Subject: Town of Exeter 1.50 MW (AC) Solar Array
9 Cross Road, Exeter, New Hampshire
Application for Type I-B Permit
Response to Incomplete Application - Request for Additional Information Application #
2023-66180 dated December 15, 2023

SETTLEMENT AND STABILITY RESPONSE

Subject: Response to NHDES letter dated December 15, 2023
Regrading Geotechnical – Global Slope Stability
Landfill located at 9 Cross Road, Exeter, New Hampshire
NHDES Application No. 2023-66180, Permit No. DES-SW-SP-1992-001

I:\SERVER\cts\Revision Energy\Exeter-NH\AcadPlans\BASE.dwg, FIG 1 - XSEC LOC, 1/19/2024 10:07:56 AM, jrl

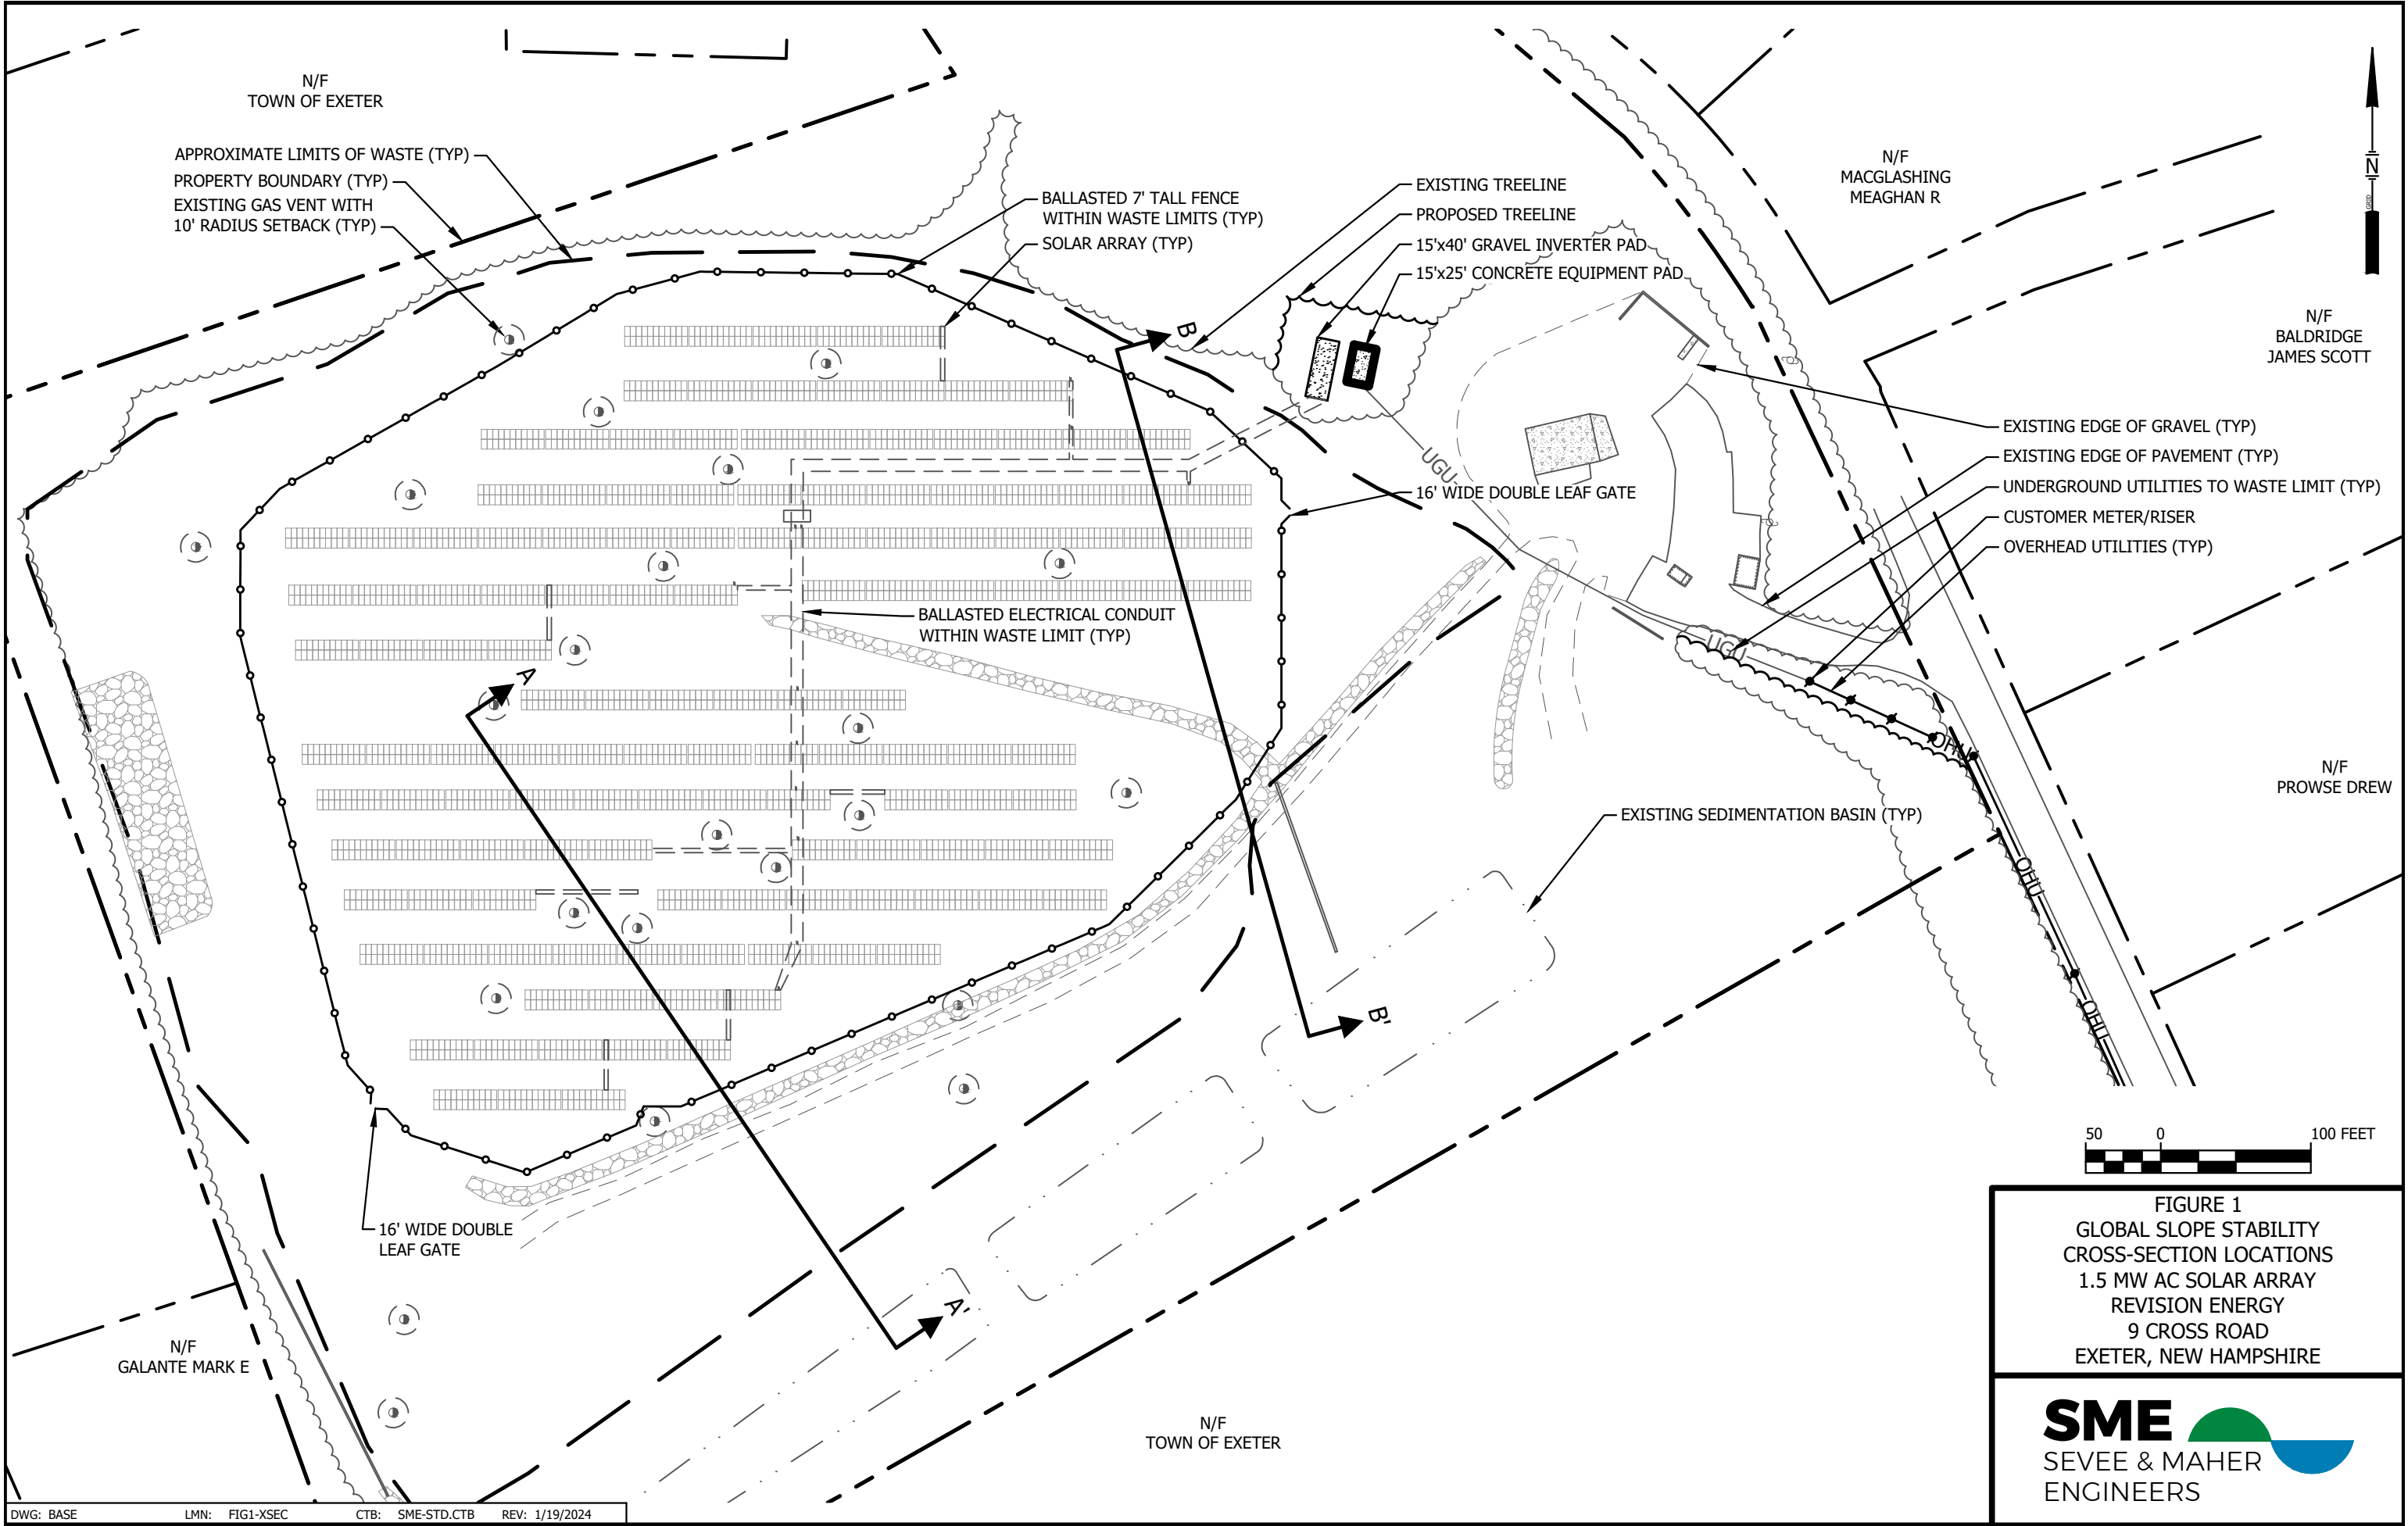
Calculations regarding global stability were not complete. Pursuant to Env-Sw 315.05(c)(5) and Env-Sw 1103.05(h), and to assist NHDES in its review of the requirements in Env-Sw 800, please provide an analysis of global stability for the static and seismic conditions using the total loading of the solar array system. Ensure stability calculations incorporate snow loading.

Two landfill cross-sections (A-A and B-B) were selected for evaluation of global (i.e., overall) slope stability with respect to installation of the proposed solar array. Figure 1 (figures are attached) shows the locations of the cross-sections relative to the landfill topography and horizontal limits of the waste deposit. Cross-section A-A is representative of a location where seven solar panels will be located on the gradually sloping top area of the landfill, whereas Cross-section B-B is representative of a steeper portion of the landfill top area where four solar panels will be positioned. Cross-sections A-A and B-B are considered to represent the combination of solar panels and ground slope variables the array will be comprised of. Figures 2 and 3 show the geometries of Cross-sections A-A and B-B and the solar panel locations. Slope stability was evaluated at two locations along each of the cross-sections. (1) Slope stability was evaluated for the portion of the cross-sections representing the southern sideslope of the landfill (where no solar panels will be placed, but where the landfill slope

The ground surface for the geometry of Cross-sections A-A and B-B follows the elevation contours shown on Figure 1. Since the landfill was capped with a 3.5-foot-thick soil cover in approximately 1996, the cover is included as the uppermost layer on the cross-sections. The waste deposit beneath the soil cover is principally municipal solid waste (MSW) of unknown thickness. The USDA – Natural Resources Conservation Service soil map for the landfill area shows the landfill to be located in a former sand and gravel borrow pit. The base of the landfill was approximated by projecting the ground surface topography on the southern side of the landfill to the lateral limit of the waste of the northern side of the landfill using a minimal slope angle (to simulate the floor of a borrow pit). Geotechnical properties (i.e., density and shear strength) for the cross-sections are summarized as the inset tables shown on Figures 2 and 3. Attachment 1 includes the basis for those property values. Note that the cover soil density (i.e., Gamma) on the inset tables includes a density increase representation of a 5-foot overlying snow depth. The mathematics supporting the density increase are included in Attachment 1.
